### **HENDERSON COUNTY TECHINICAL REVIEW COMMITTEE**

**SUBJECT:** Revised Combined Master and Phase II Development Plan for Couch Mountain (Formerly Luna Ridge) Major Subdivision (2019 – M03)

**Henderson County Planning Department Staff Report**

**Combined Revised Master and Phase II Development Plan  
Couch Mountain Major Residential Subdivision (2019-M03)**

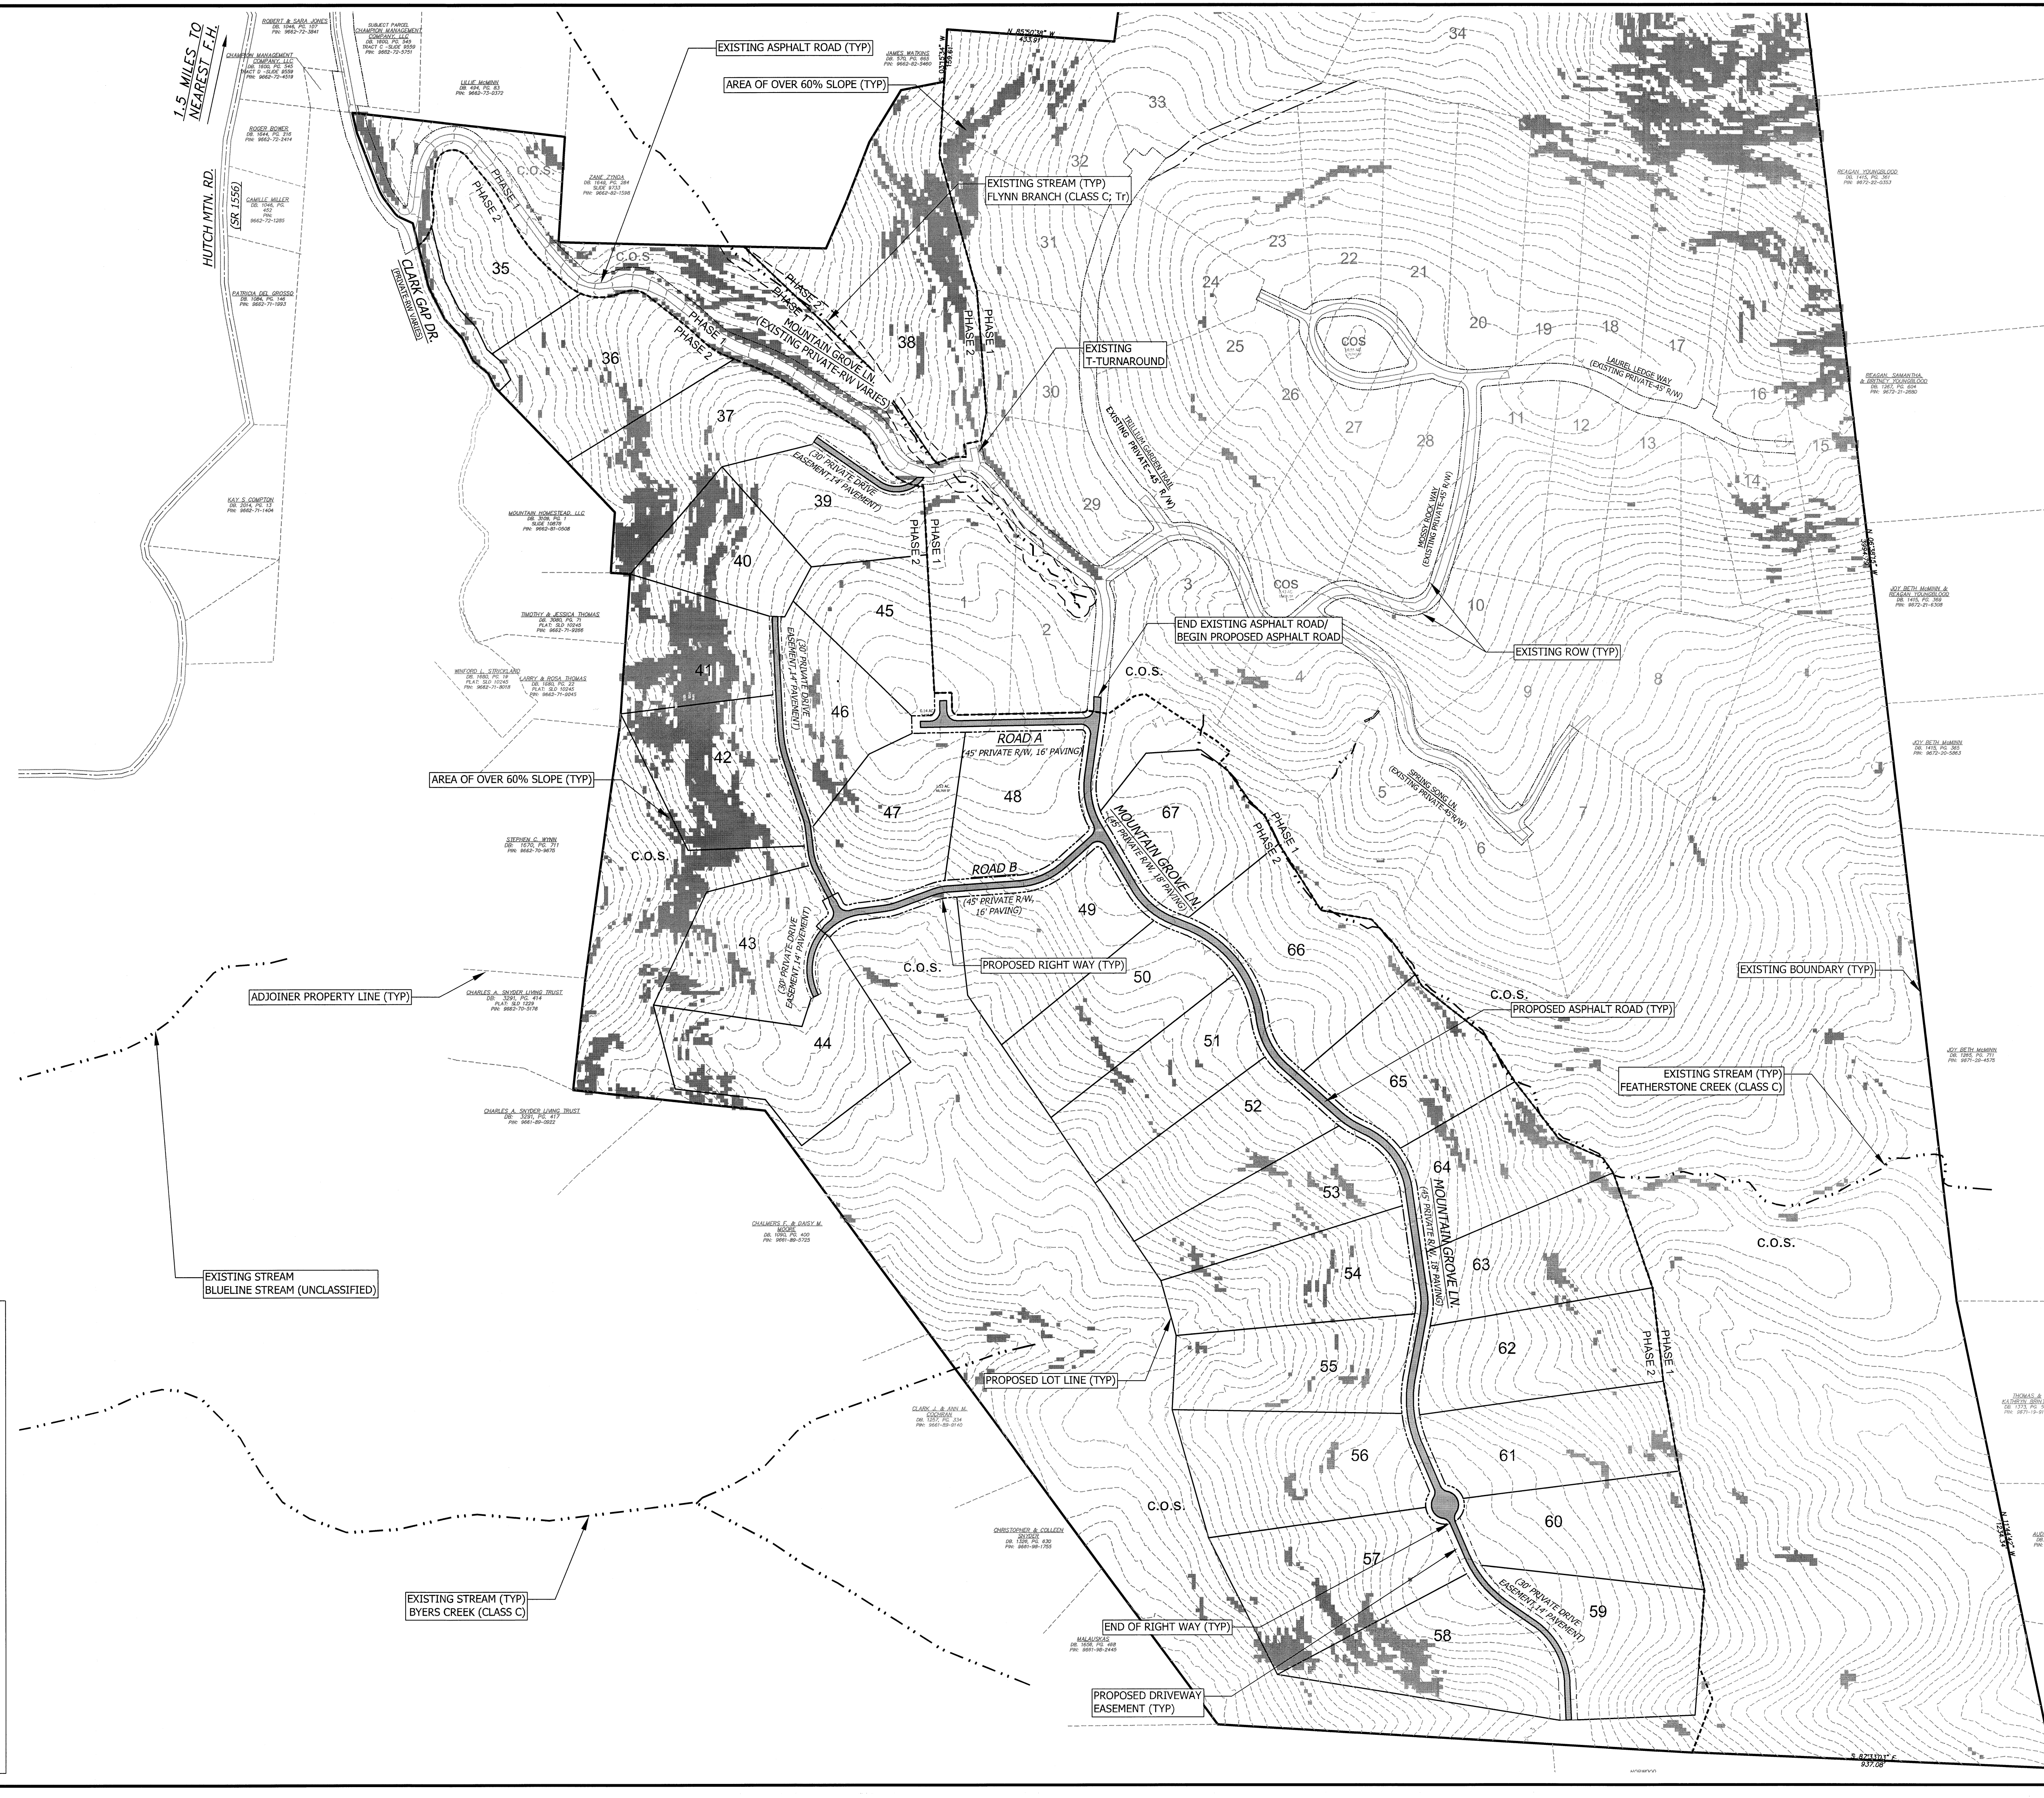
1. **Soil Erosion and Sedimentation Control Plan.** The Applicant shall submit written notice from the appropriate local agencies verifying that an Erosion and Sedimentation Control Plan has been received or a written notice from a professional land surveyor, engineer, landscape architect, architect, or professional planner certifying that no plan is required (LDC §42-95B).

2. **Private Roads.** Private roads shall be constructed in accordance with the Private Subdivision Local Road standards stated in Chapter 42 (LDC§42-109). Additionally, subdivisions of 35 or more lots shall provide a minimum of two entrance roads. The second entrance road may be specifically waived by the approving authority where unique circumstances exist (LDC §42-95A (1)).

3. **Shoulder Stabilization.** All areas disturbed by the construction of a public road, including cut and fill slopes, shoulders and ditch banks, shall be seeded to stabilize the soil and prevent erosion. Seeding should be done as soon as feasible after road construction (LDC §42-102).

4. **Road Drainage, Culverts and Shoulder Stabilization.** Road or drainage structures shall be constructed in accordance with state roads standards. Road drainage side ditches shall be constructed with sufficient depth and width to carry the expected volume of storm water runoff (LDC §42-100). All areas disturbed by the construction of a public road, including cut and fill slopes, shoulders and ditch banks, shall be seeded to stabilize the soil and prevent erosion. Seeding should be done as soon as feasible after road construction (LDC §42-105).

5. **Road Name Approval.** Proposed road names for a private and/or public road shall be preapproved by Henderson County in accordance with Chapter 42 of the Henderson County Code, Property

Addressing (LDC §42-103). The names of the proposed roads and easements should be confirmed with the development plan approval.

6. **Road Name Signs and Regulatory Signs.** Road name signs and regulatory signs shall be provided in accordance with Chapter 142 of the Henderson County Code. Road name signs and regulatory signs must be acquired and installed prior to final plat approval (LDC §42-104).

7. **Street Tree Requirements.** According to the street tree requirements of Chapter 42 (LDC §42-95H) the applicant must provide one tree per 50 linear feet of property abutting an internal road. Trees may be placed in groups with a minimum spacing of no less than 15 feet and a maximum spacing of no more than 65 feet. The trees may be placed within the right-of-way or within 20 feet of the edge of the right-of-way. The applicant may use existing trees in accordance with LDC §42-185 instead of planting new trees. These existing trees must also be located within the right-of-way or 20 feet off the edge of the right-of-way as required by LDC §42-185.

8. **Perennial and Intermittent Surface Water Buffer.** All built-upon area shall be a minimum of 30 feet landward of all perennial and intermittent surface water, as defined in LDC §42-251.
